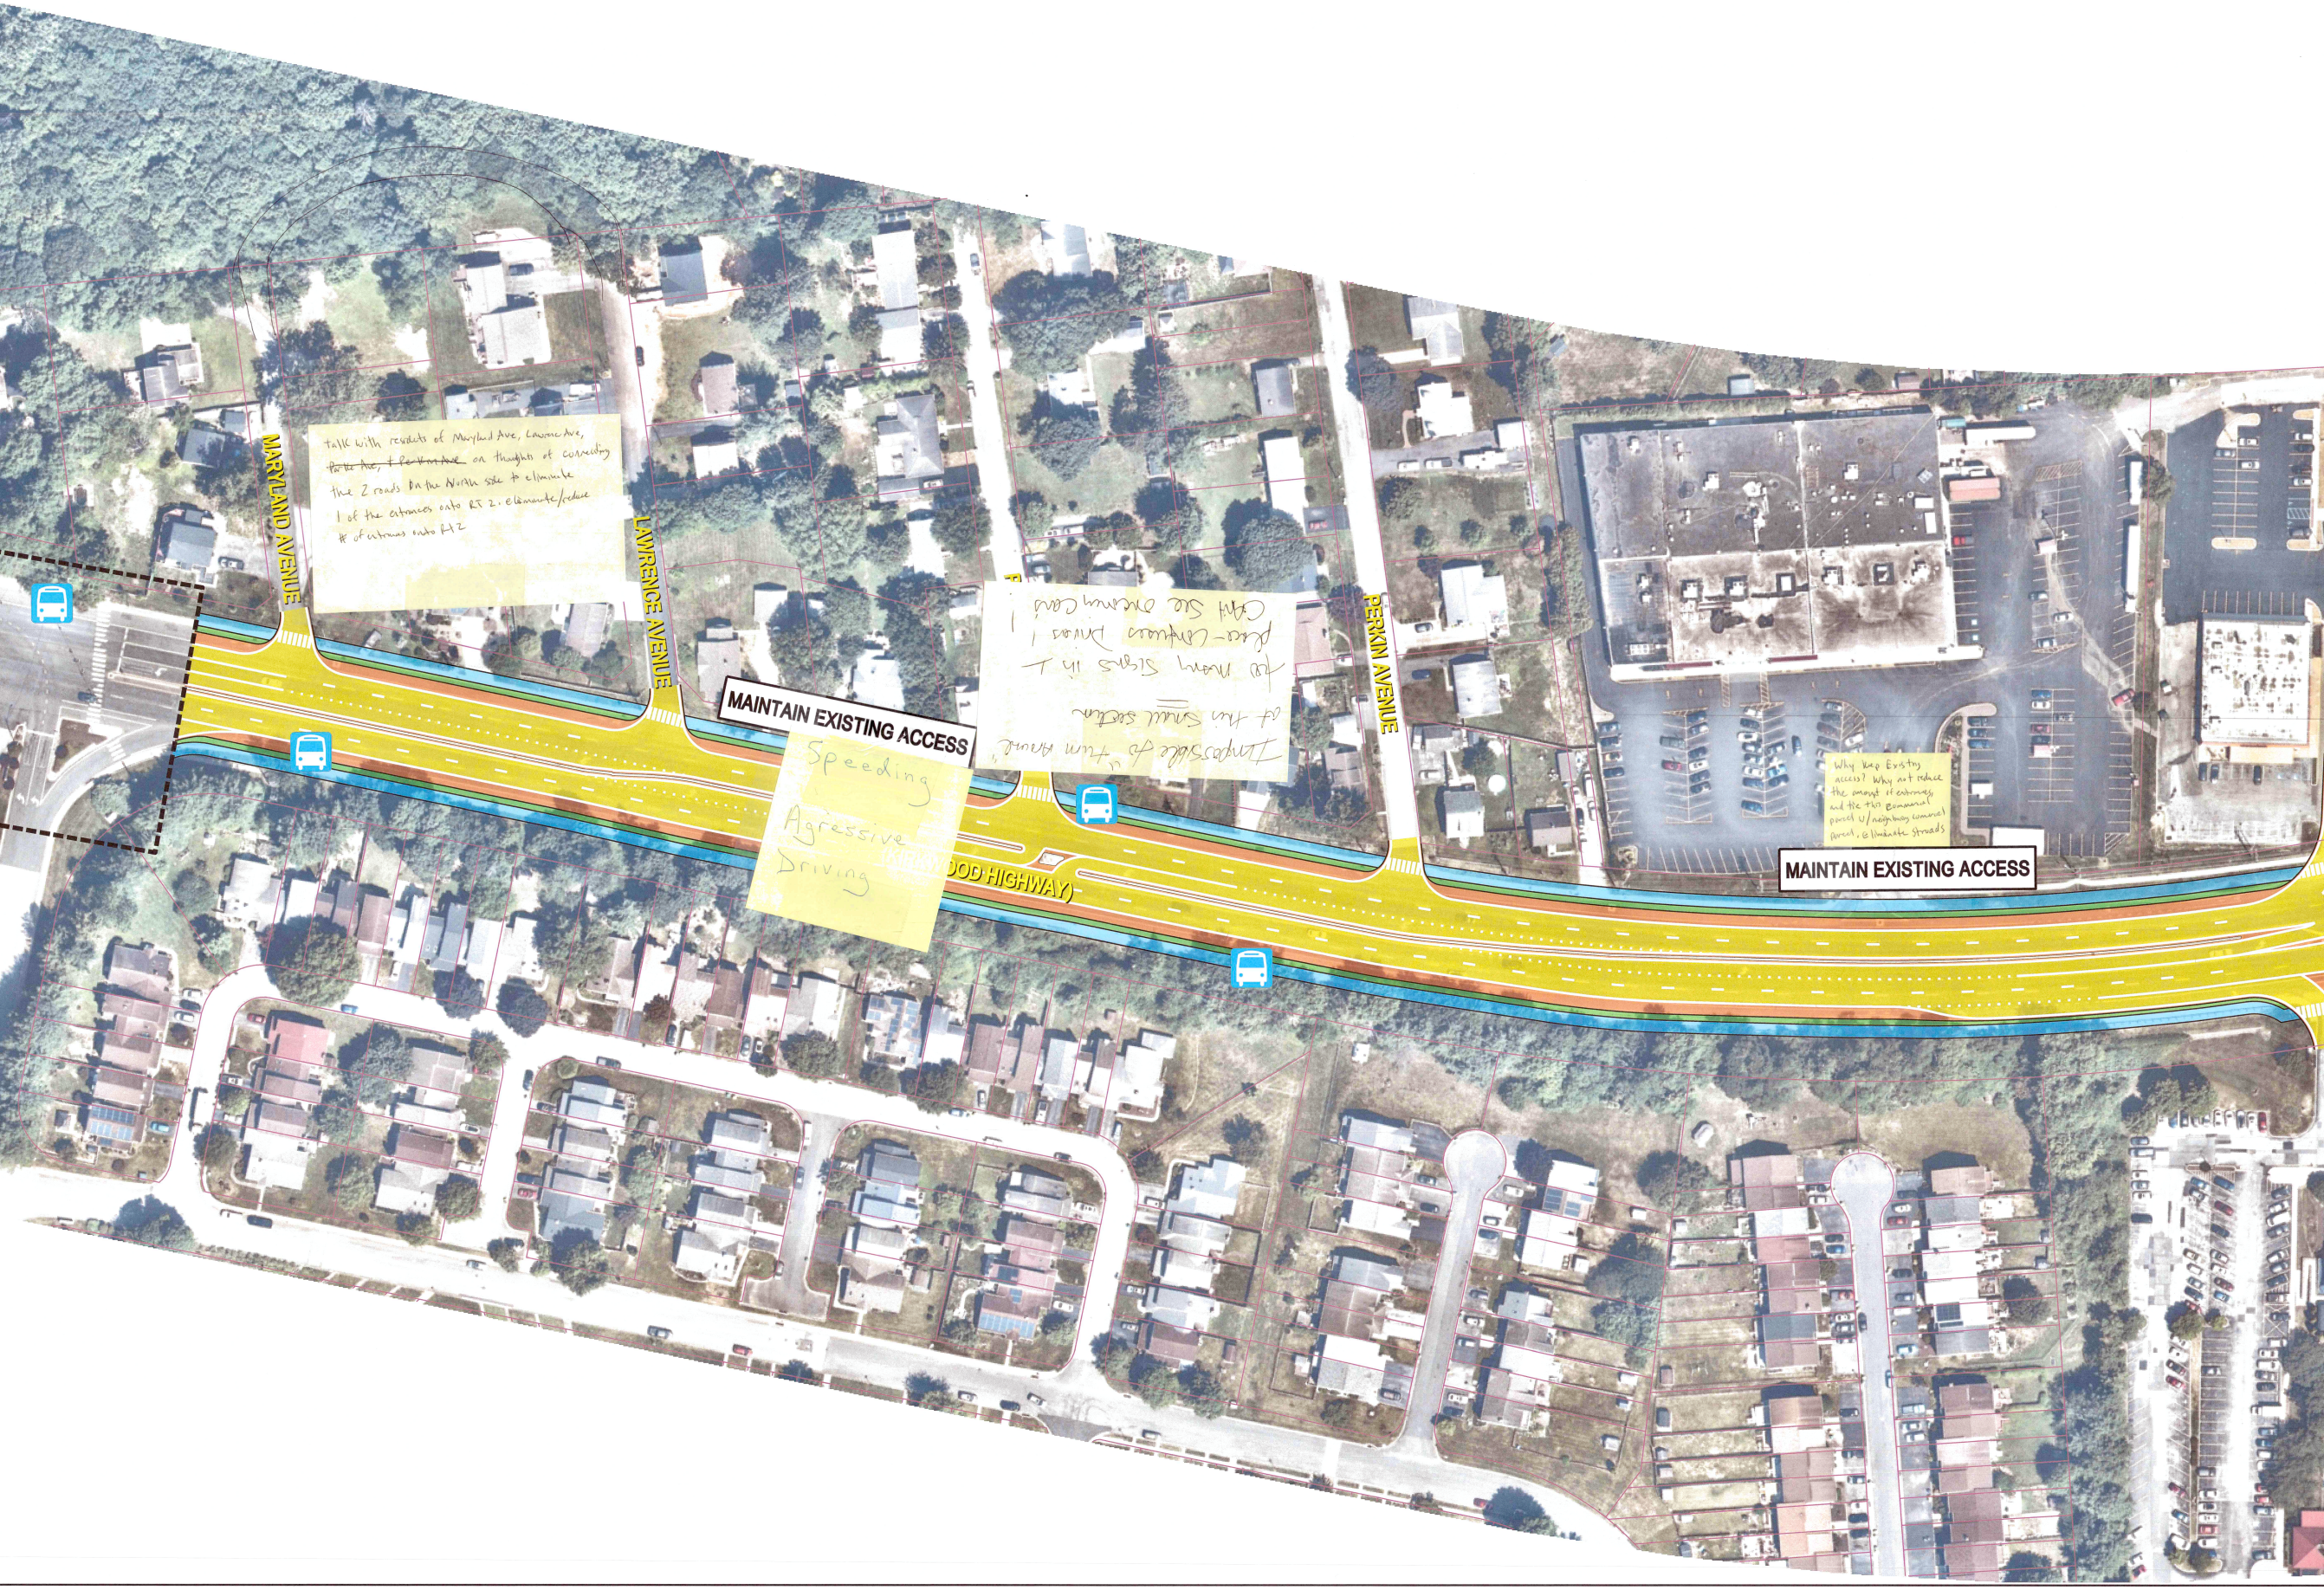
talk with residents of Maryland Ave, Lawrence Ave, ~~Parkie Ave, + Perkin Ave~~ on thoughts of connecting the 2 roads on the North side to eliminate 1 of the entrances onto RT 2. eliminate/reduce # of entrances onto Rt 2

Impossible to "turn Around" at this small section

too many signs in 1 place - Confuses Drivers! CAN'T See oncoming cars!

Speeding

Agressive Driving

Why keep Existing access? Why not reduce the amount of entrances, and tie this commercial parcel w/ neighboring commercial parcel, eliminate streads

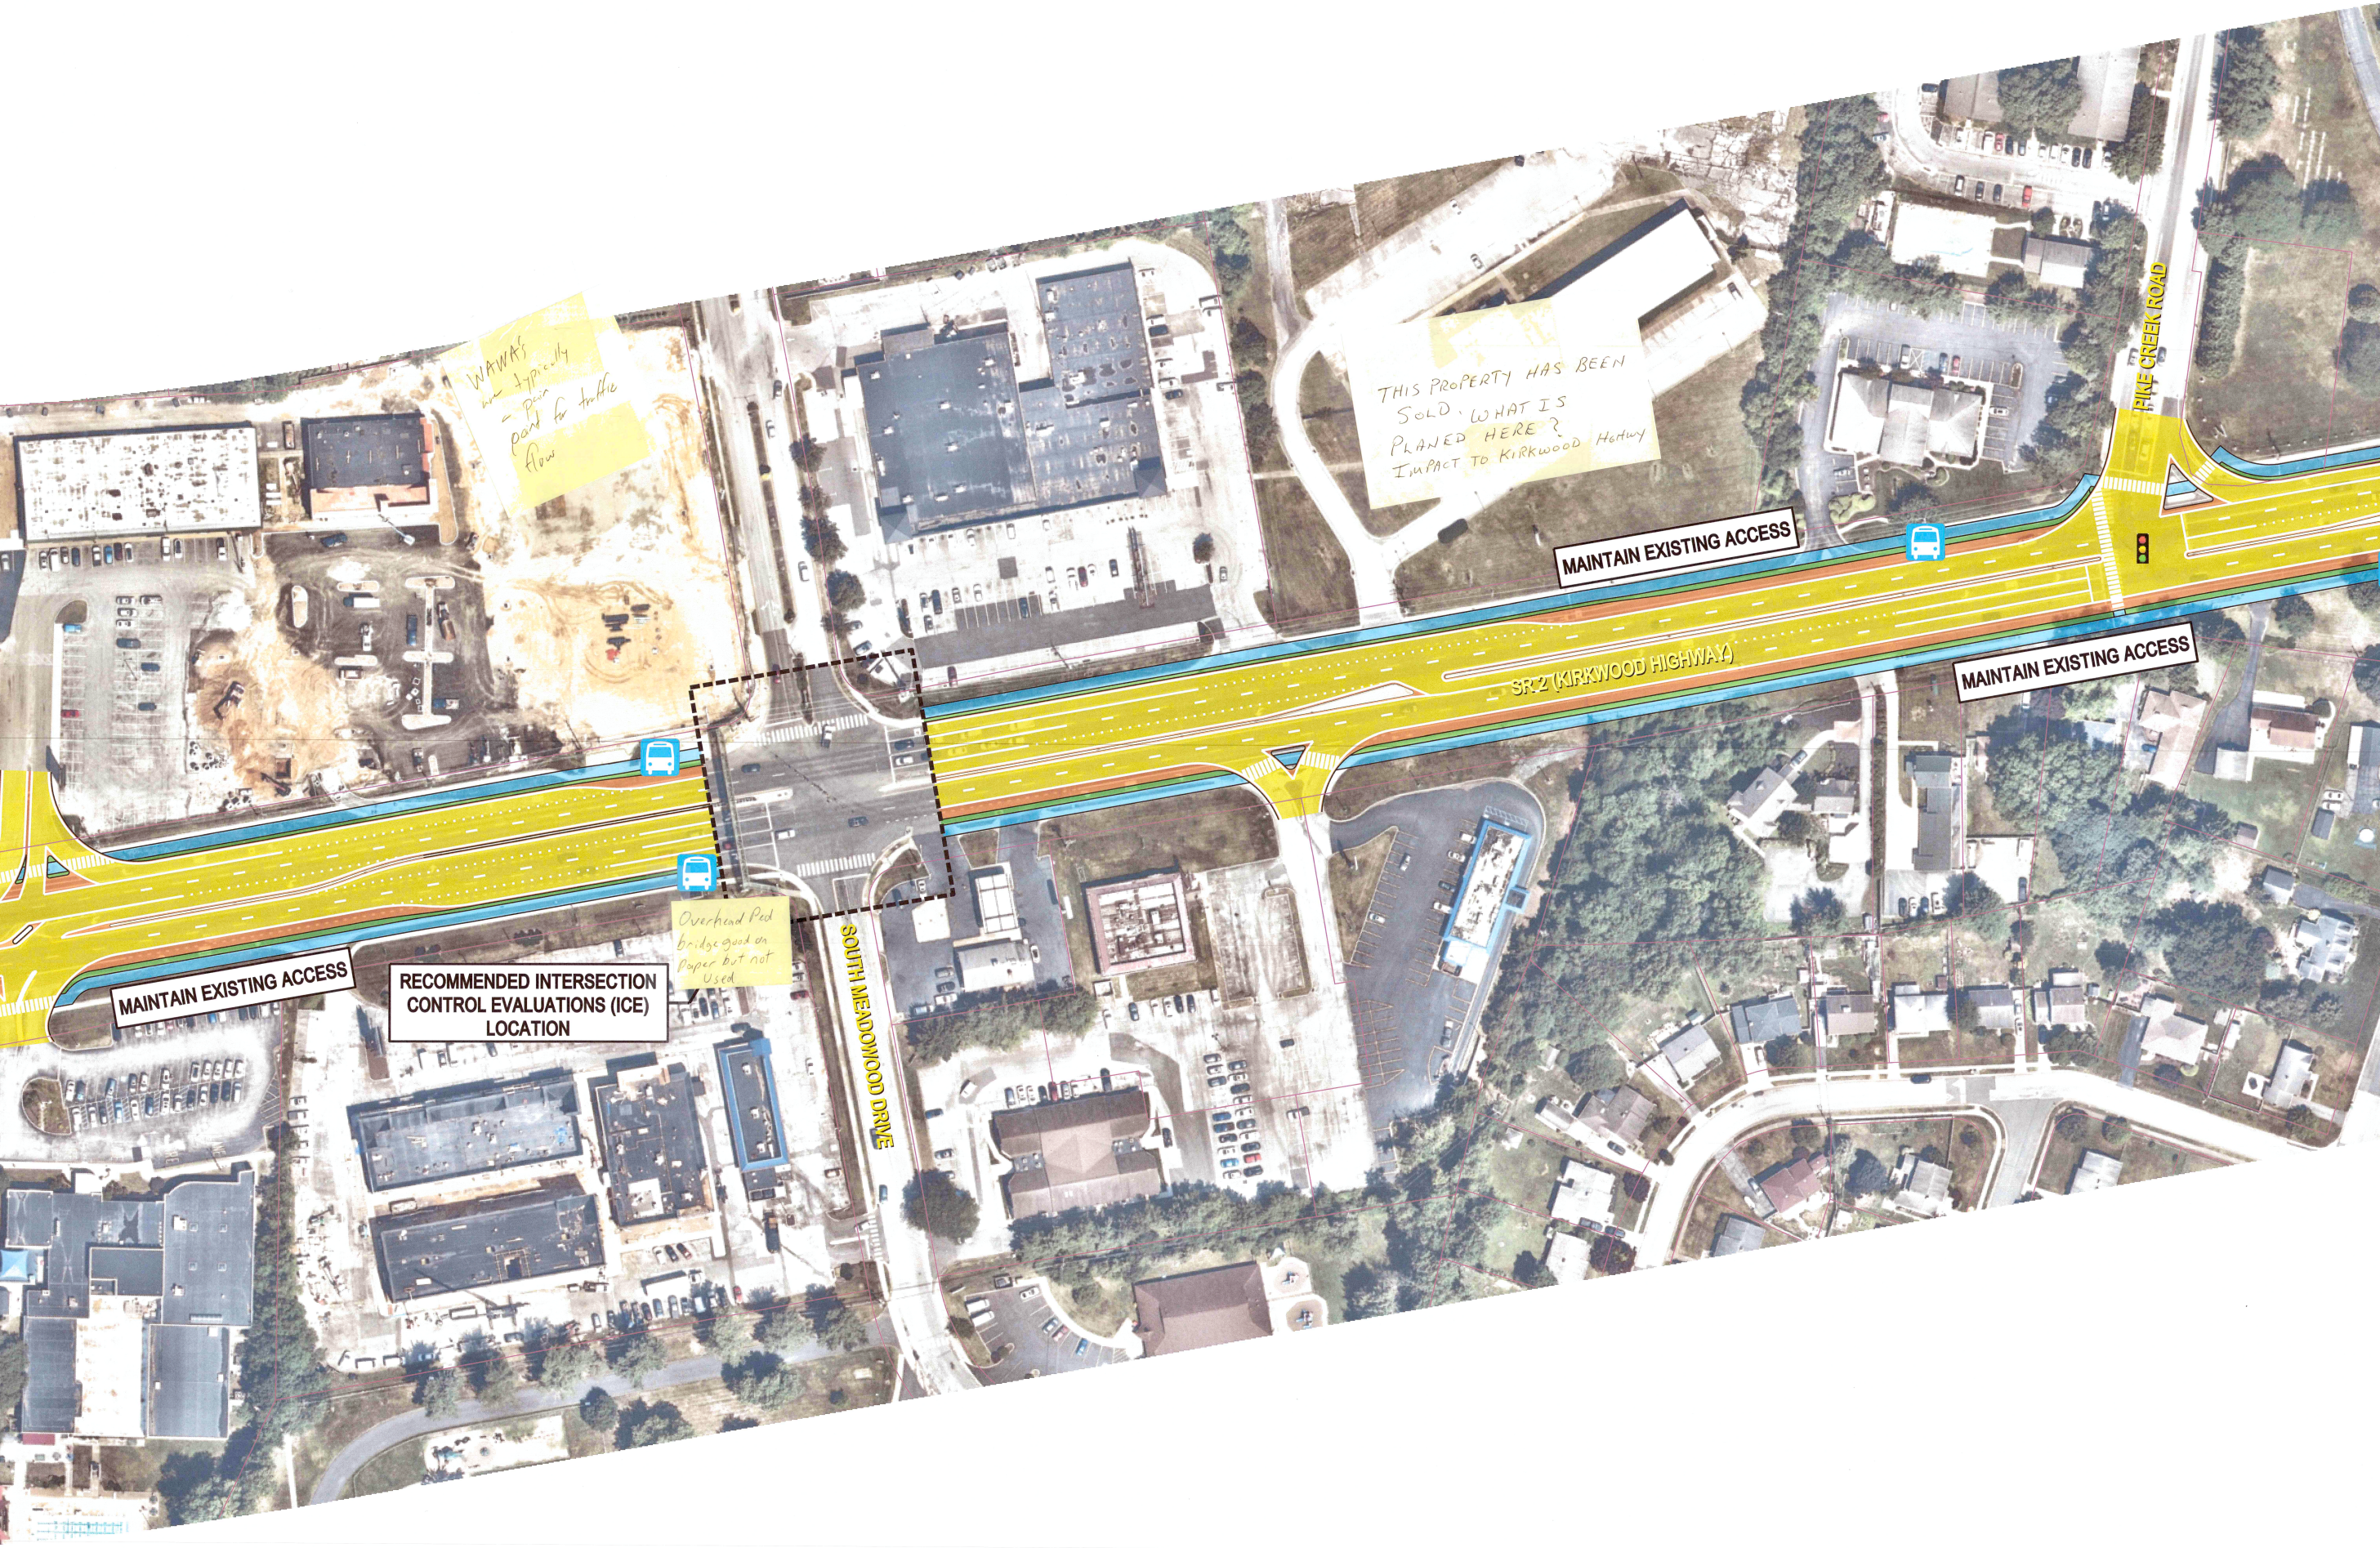
WAWA's
are typically
– pain
point for traffic
flow

THIS PROPERTY HAS BEEN
SOLD. WHAT IS
PLANED HERE?
IMPACT TO KIRKWOOD HGHWY

Overhead Ped
bridge good on
paper but not
Used

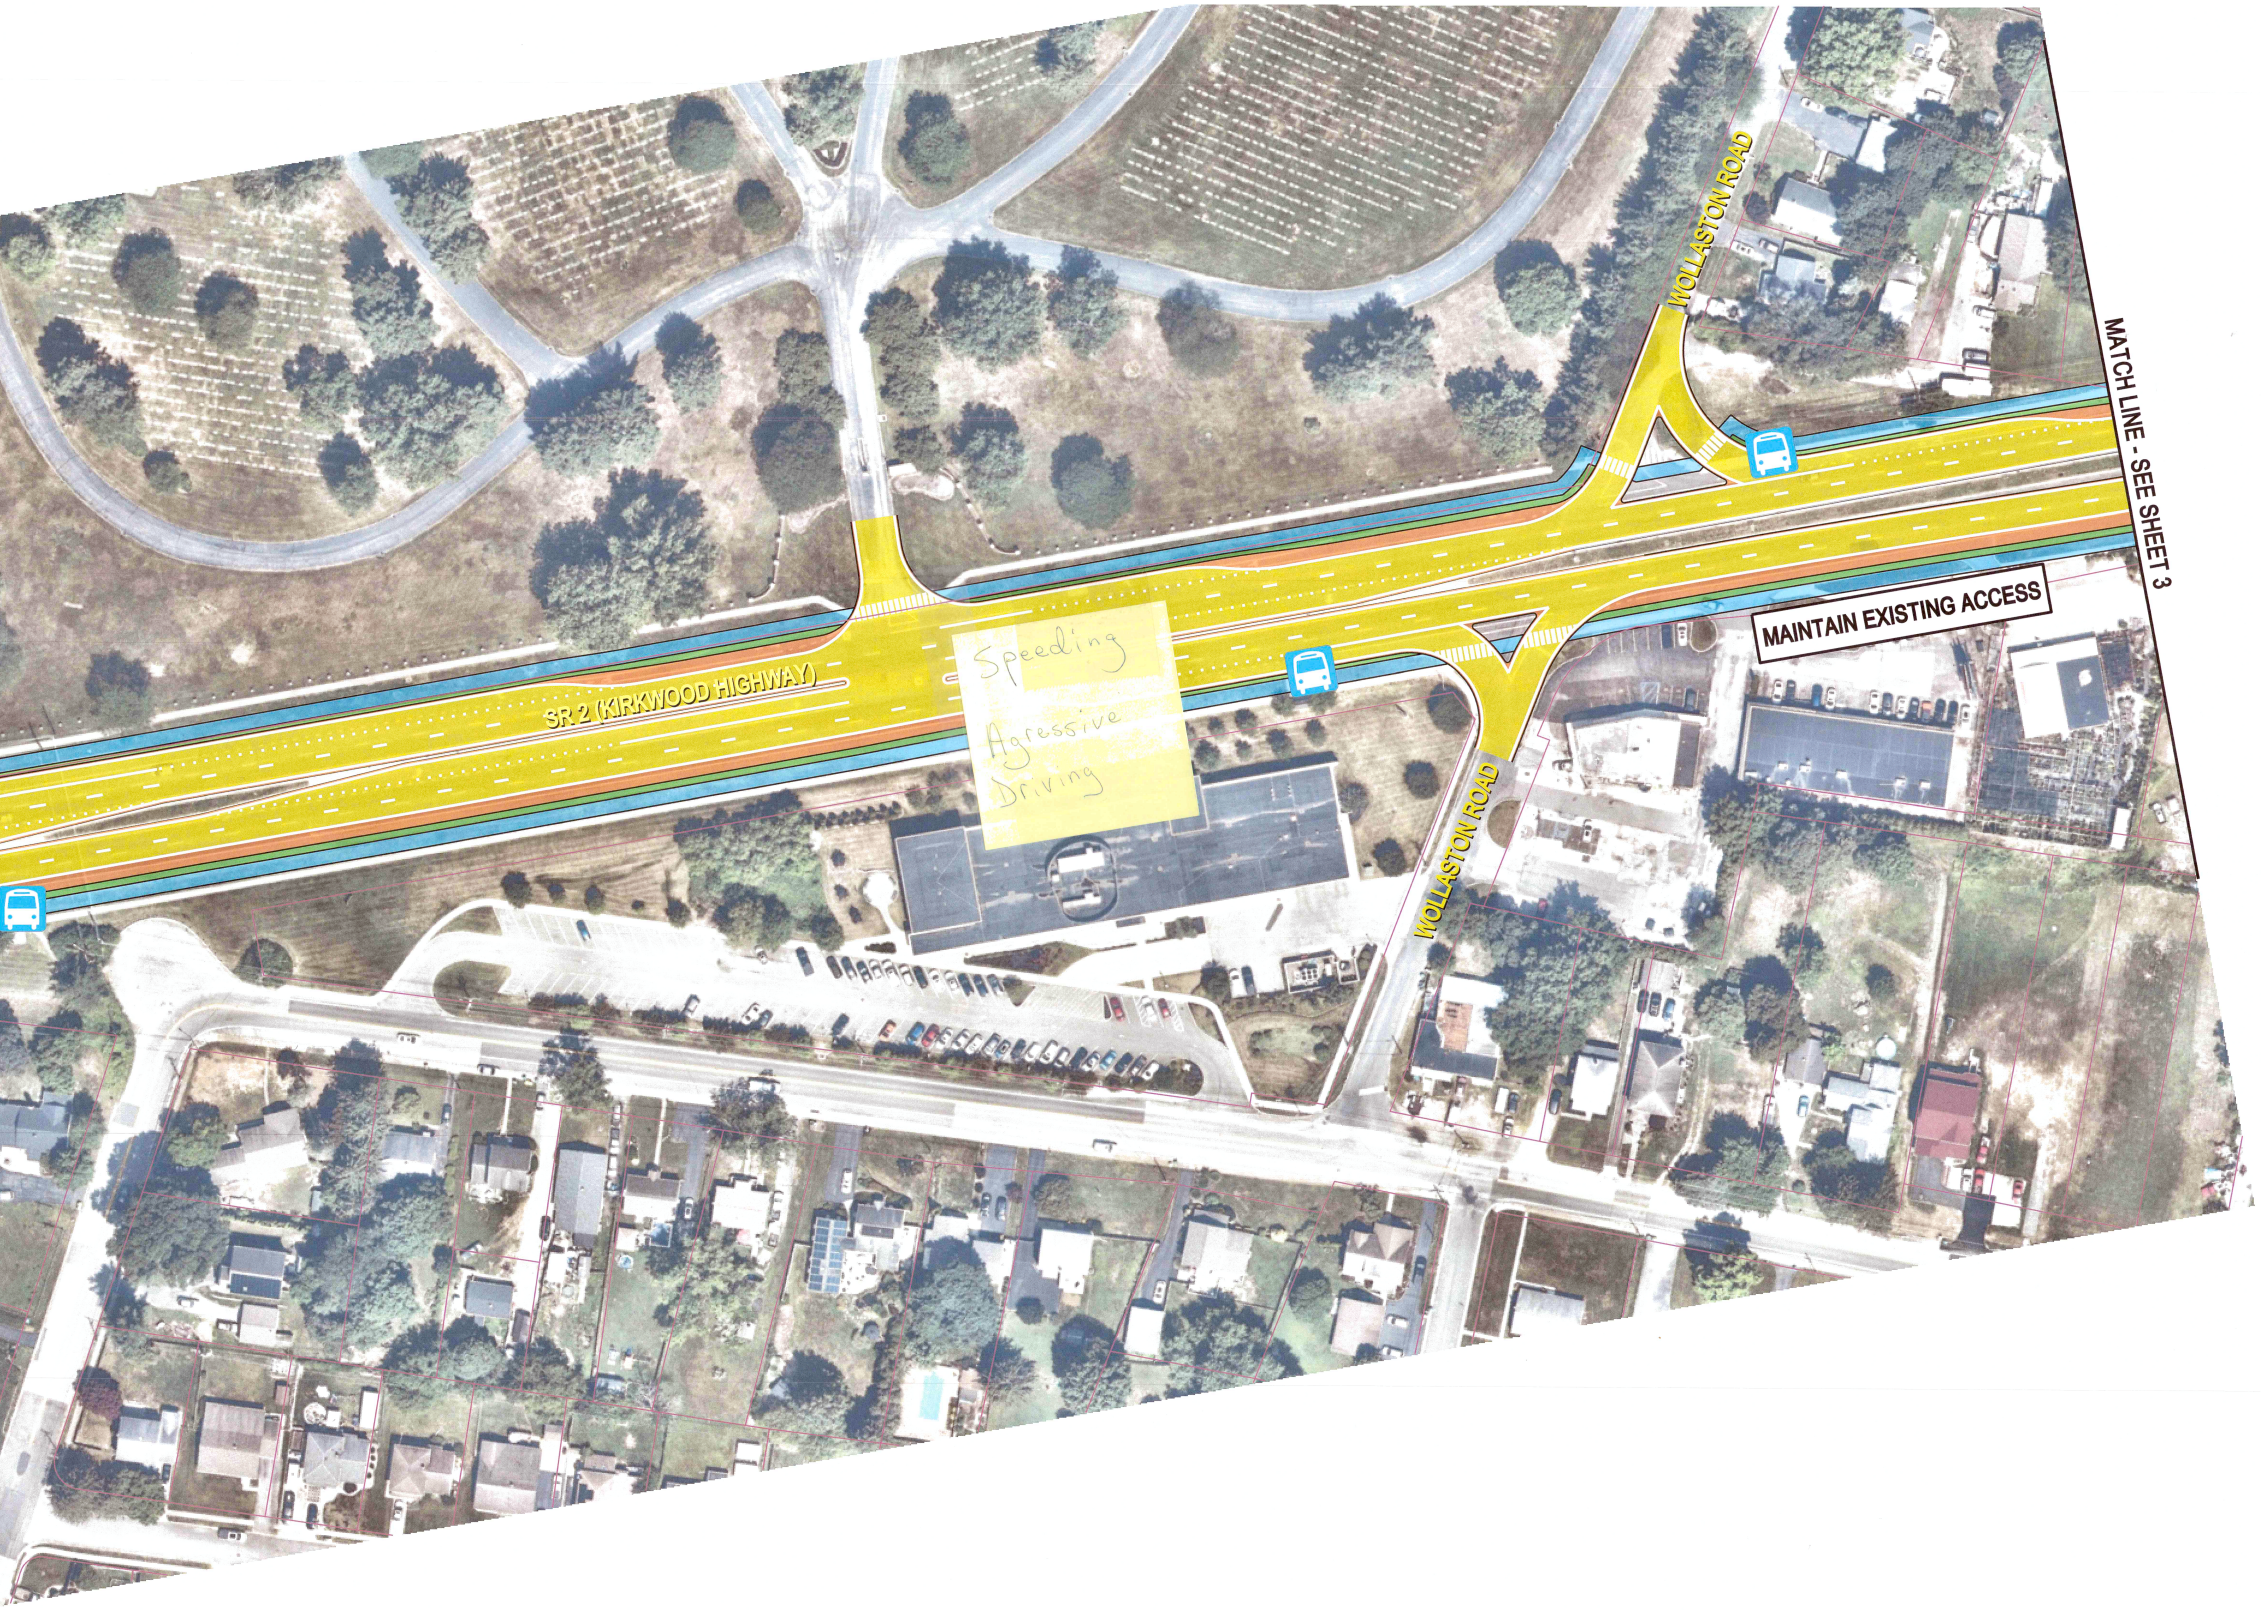
Speeding

Agressive Driving
